COUNCIL ACTION FORM

SUBJECT: MAJOR REVISIONS TO PREVIOUSLY APPROVED WESTWOOD VILLAGE MAJOR SITE DEVELOPMENT PLAN

Attachment G
Proposed Modified Layout

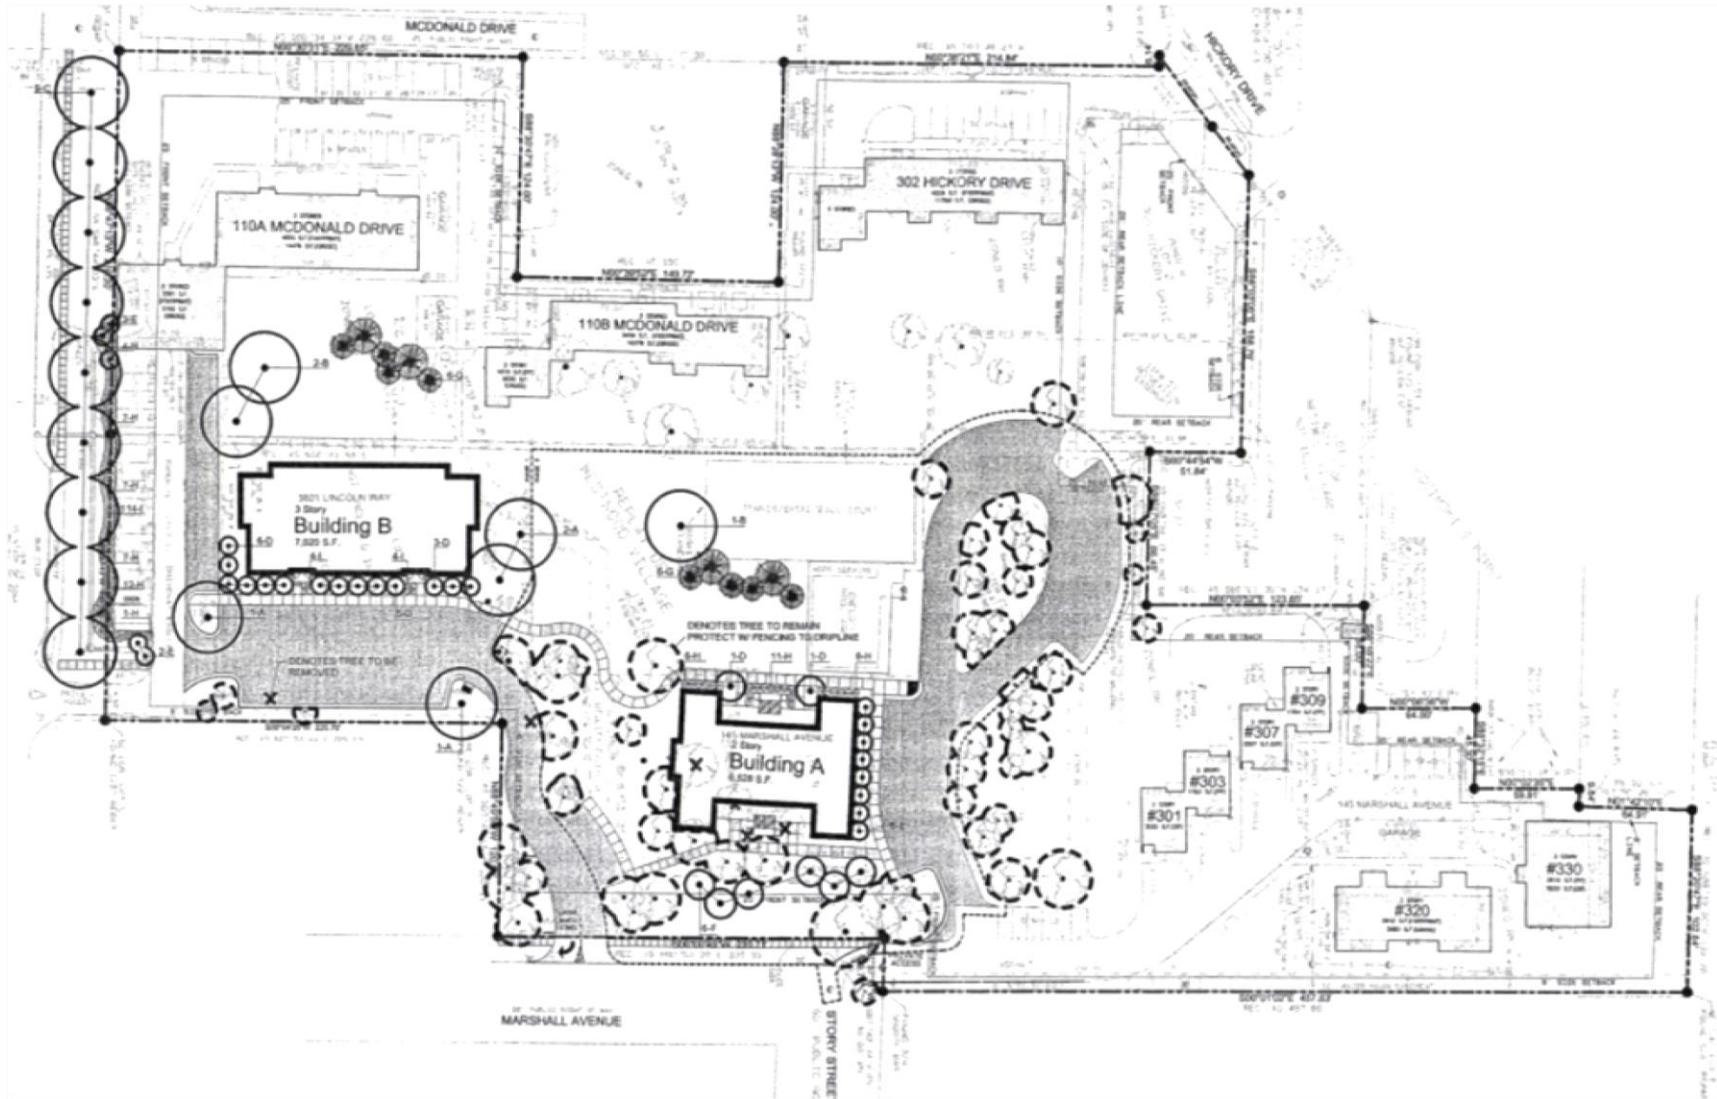
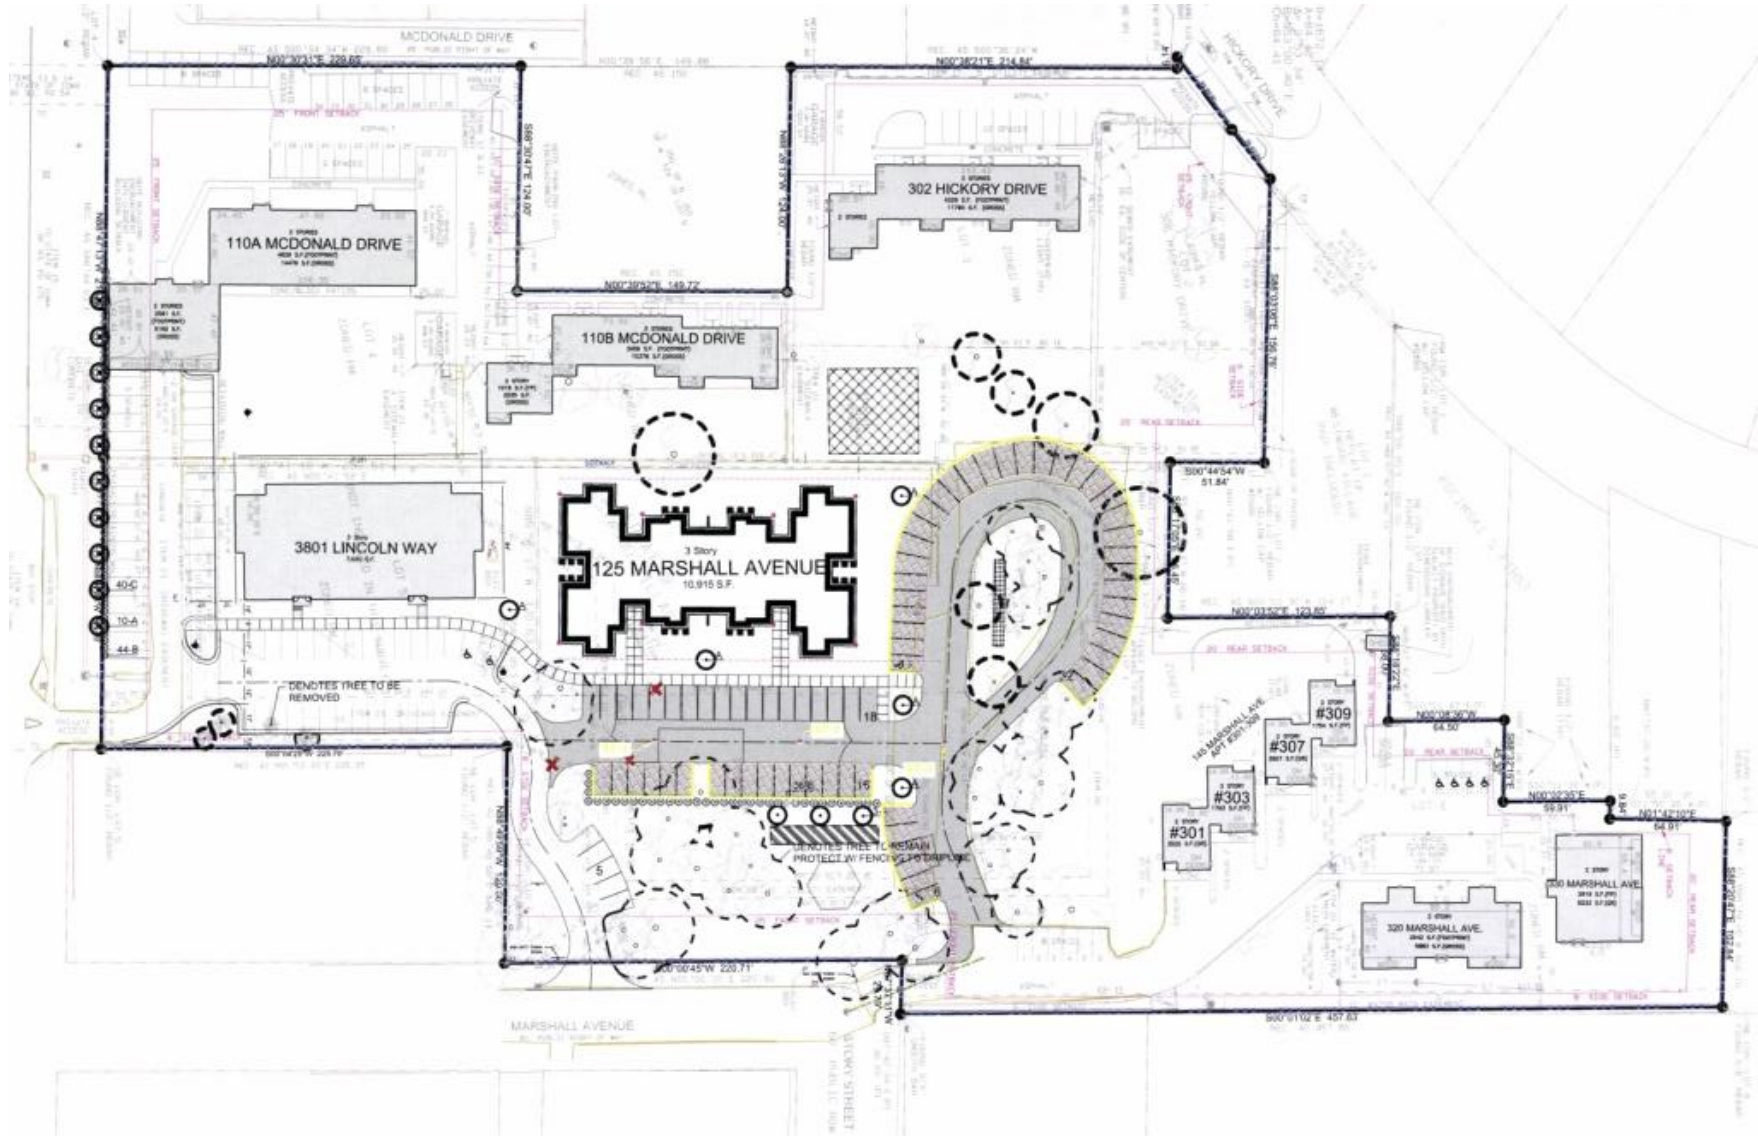
The property owner/applicant is requesting approval of modifications to the previously approved Westwood Village Major Site Development Plan (MSDP). (See Attachment F Existing Approved Layout and Attachment G Proposed Modified Layout.) **The overall changes involve changing an approved 16 unit building to a 24 unit building (to be addressed as 125 Marshall) with its associated parking and circulation. The proposed amendments to Westwood Village increase the overall density of the project, increase the building footprint, and place the proposed building closer to its west lot line and to existing buildings.**

- Building is moved north and further from the street
- Building is moved closer to existing buildings and creates a 15-foot setback from the rear property line of the lot on which it is located

- Building foot print is increased in area from 6,500 square feet to 10,900 square feet
- Building height is increased from a two-story to a three-story building

- Dwelling units in the building are increased from 16 units to 24 units
- Dwelling units in the total project are increased from 97 units to 105 units
- Bedrooms in the building are increased from 24 bedrooms to 72 bedrooms

- Bedrooms in the total project are increased from 169 to 217
- Density of the total project is increased from 13.5 dwelling units per acre to 14.6 dwelling units per acre

- Total number of parking spaces on the site is increased from 196 spaces to 248 spaces (239 spaces are required for the proposed number of bedrooms)
- Parking area with 34 spaces is added south of the building

- Where parking paving is proposed under the drip line of mature oak trees, pavers over crushed clean granite are proposed to minimize impact on tree roots
- Portion of the total site that is open space is decreased from 86% to 54.2%
- Central recreation space is reduced, swimming pool is removed, basketball court is reduced in area, and bocce ball court and picnic shelter are added south of the building

Having said this, however, I do appreciate the fact that the new plan for the apartments shows the new structure (though larger) has been moved back west away from the Oak Grove. However, the road and 34 parking spaces east of the proposed apartment unit are too close to the Oak Grove and the access road through the south edge of the Oak Grove is unnessesary and threatens the life of the trees.

The use of gravel and pavers for parking under the dripline of the existing trees is a nice gesture. The dripline, however, does not reflect the root growth that extends out from trees in every direction and in many cases as far away from the trunk as the height of the tree (80 or 90 feet). Also when any construction occurs near any Oak tree there is always risk of damage to the tree that will not show up for a year after the construction is completed.

In addition, I see no need to remove any existing trees on the basis of not being close to the main grove of trees or on the premise of being diseased. Especially one particularly grand Oak standing by itself on the northern edge of the property. An absence of 2 or 3 parking spaces would be much better than a removal. These trees are not diseased and being old does not make them more suseptable just more revered.
